# Request for Quotation

RFQ NUMBER  
**DEP13017**

| LINE   | QUANTITY | UOP | CAT NO | ITEM NUMBER | UNIT PRICE | AMOUNT |
|--|----------|-----|--------|-------------|------------|--------|
| <p>*****<br/>           ADDENDUM NO. 1 *****<br/>           ADDENDUM ISSUED FOR THE CHICOPEE COAL CO. PROJECT AS A RESULT OF THE MANDATORY PRE-BID MEETING OF 02/19/10. FOLLOWING ARE THE TWO (2) PRE-BID SIGN-IN SHEETS, TWO PAGES OF AGENCY CLARIFICATIONS OF SCOPE OF WORK, NOTED CHANGES TO THE BID SCHEDULE, Q/A FROM THE PRE-BID, A REVISED SKETCH, AND FOUR (4) PAGES OF REVISED BID SCHEDULES.<br/>           BID OPENING DATE &amp; TIME ARE EXTENDED FROM 03/17/10 TO 03/24/2010 AT 1:30 PM.<br/>           ***** NO OTHER CHANGES *****</p> |          |     |        |             |            |        |

Re: Chicopee Coal Co  
Permit No(s): O-6013-88, O-6023-89, S-73-85, U-6018-86  
Requisition Number: DEP 13017

| POND to be ELIMINATED<br>at EXISTING REFUSE PILE |                          |

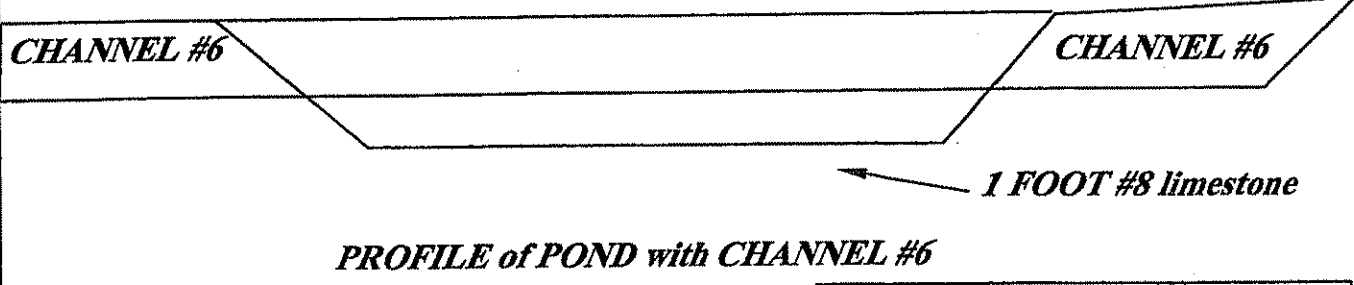
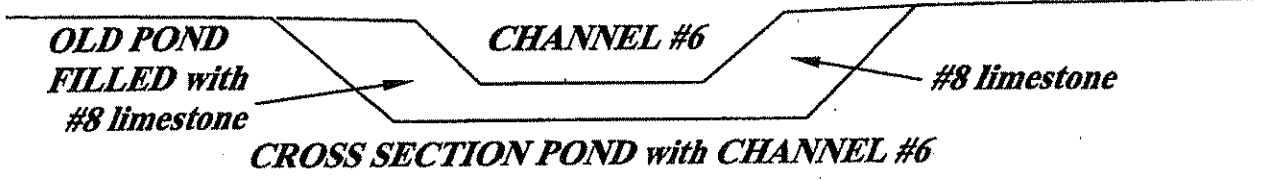
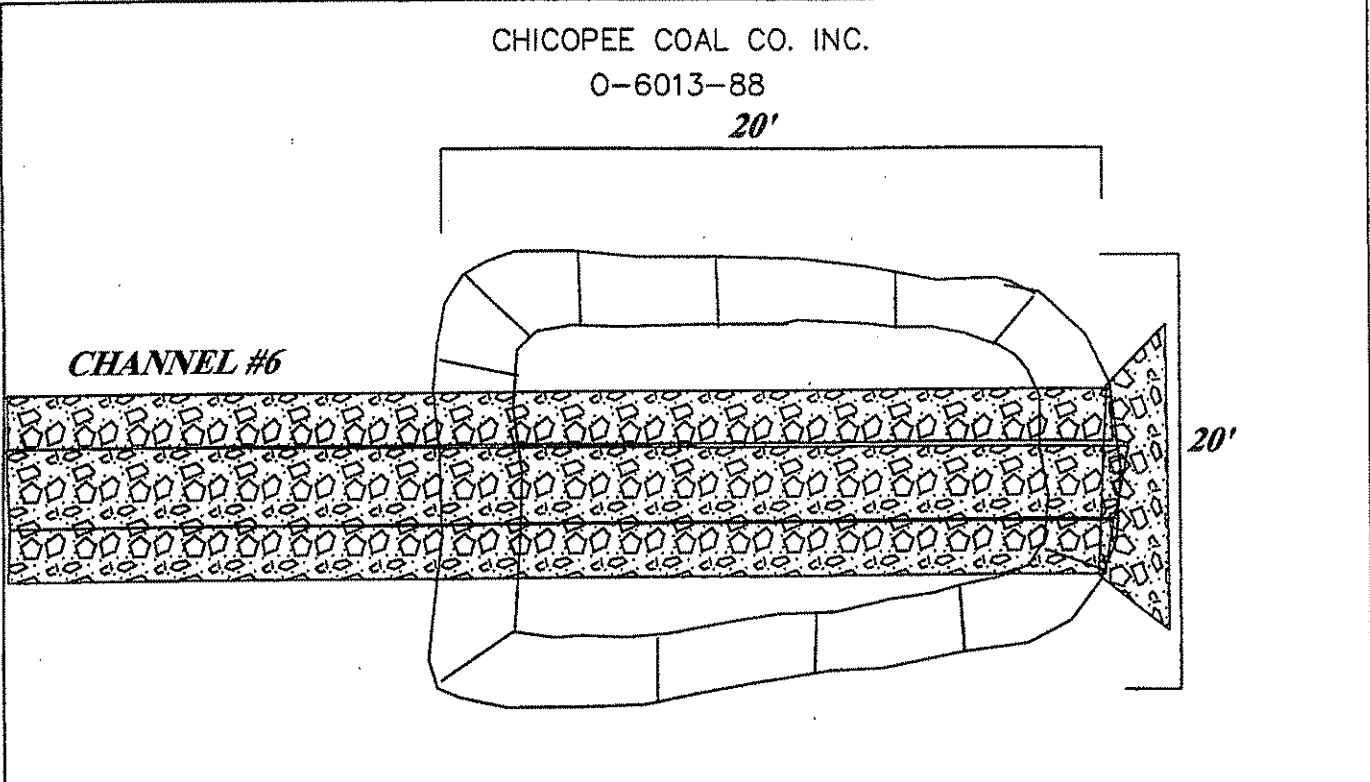
2. How much #8 limestone gravel will be required to eliminate pond at the toe of the existing refuse disposal pile?  
 Pond at the toe of the existing reclaimed refuse pile contains an appreciable amount of silt and sediment. We will provide a typical drawing giving the dimensions of the pond. See attached drawing.

**NOTE: Pond is Approx. 20' long  
 x 20' wide x 4' deep. Pond will be filled  
 with #8 Limestone and Channel #6 will  
 be constructed on top of fill area.**
